October 26, 2023

RE: Deficiency Notice
Application for a Standard Opencut Mining Permit Application
Black Site, Opencut #3462
Gallatin County

RE: Deficiency Notice
Application for a Standard Opencut Mining Permit Application
Black Site, Opencut #3462
Gallatin County

Figure. 1

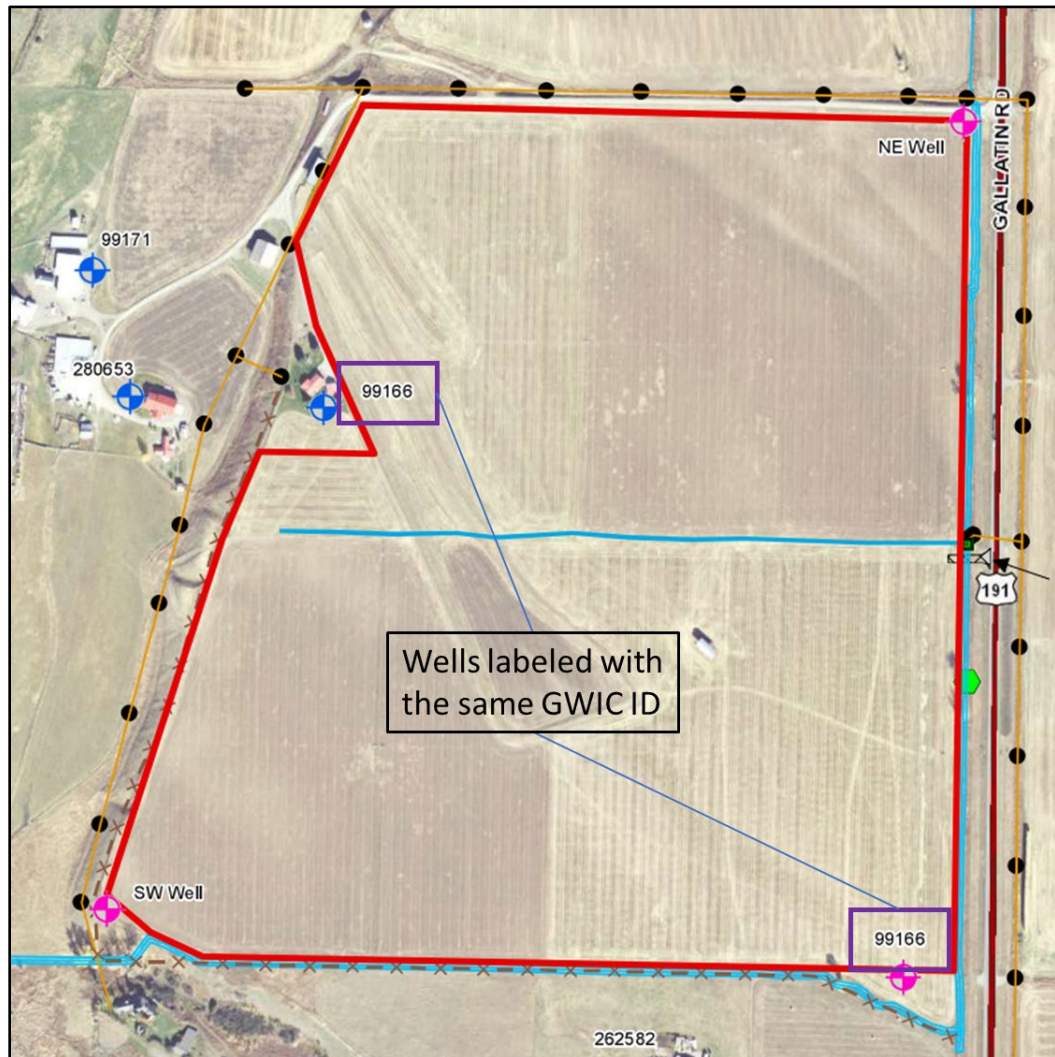
Update: There are two wells labeled “99166” on the Area Map (Figure 1). Correct these labels to ensure that all wells have correct GWIC IDs.

Additionally, public comments have identified inaccuracies in identified utilities, specifically above ground vs. buried power lines in the southwest corner of the permit boundary. Verify that the utilities shown are accurately labeled;

Figure 2.

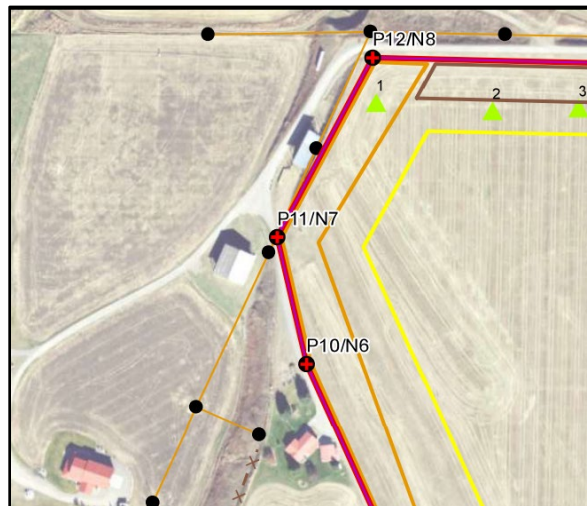
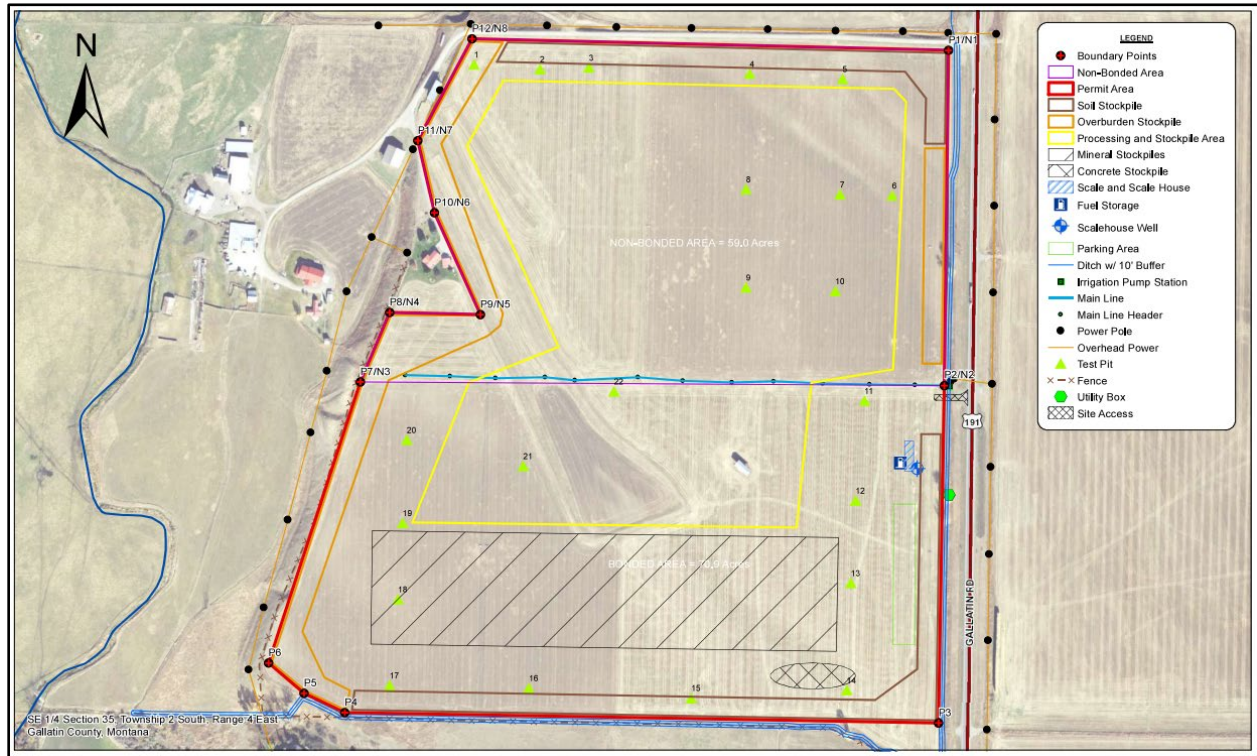
1. **B4-1:** Check the “Overline Power Lines or Facilities” and “Underground Utilities” boxes to account for the structures, facilities, and/or surface disturbances located within the permit area [ARM 17.24.218(1)]. The northwest corner of the proposed permit boundary indicates a Power Line will cross inside of the permit boundary. See Figure 1 below. The Irrigation Main Line that runs through the center of the permit boundary was not accounted for as Underground Utilities. See Figure 2 below.

Figure 4.

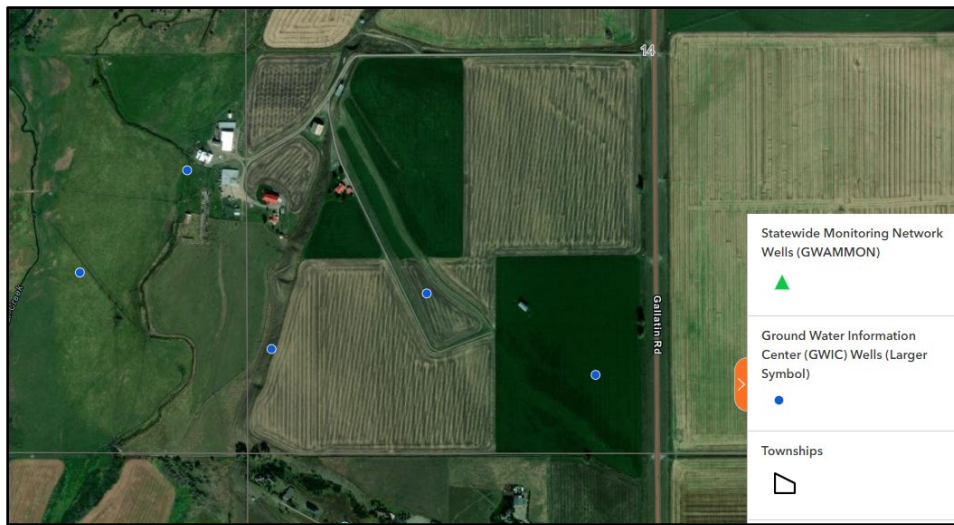
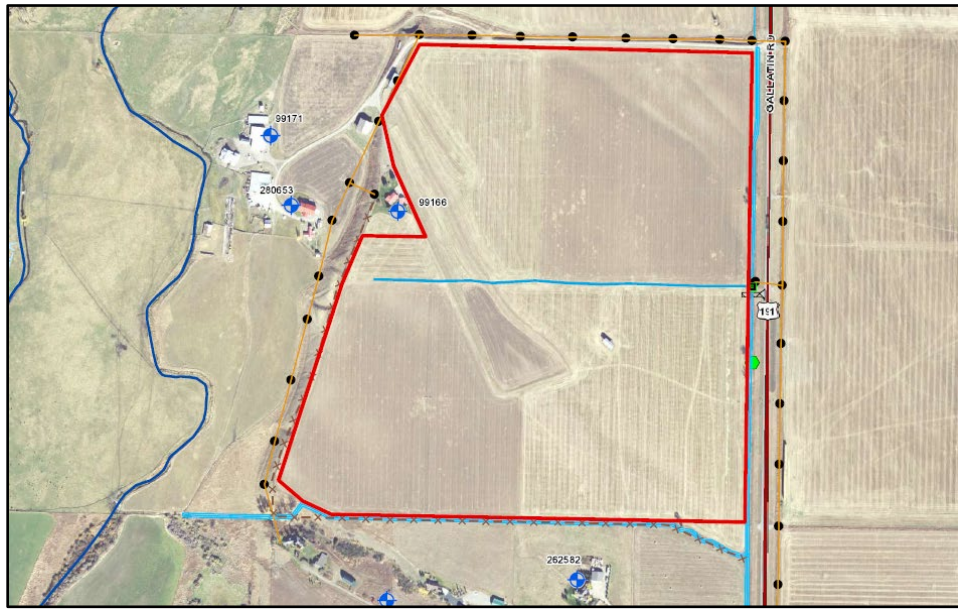
- Correct the Township, Section, and Range;
 - roads leading to the site;
 - above and below ground utilities and easements and their stated set back;
 - water wells. The Ground Water Information Center (GWIC) well locations (Figure 4.) do not match the well locations on the Area map (Figure 5.). Ensure that the locations of the wells are accurate and have been field verified; and
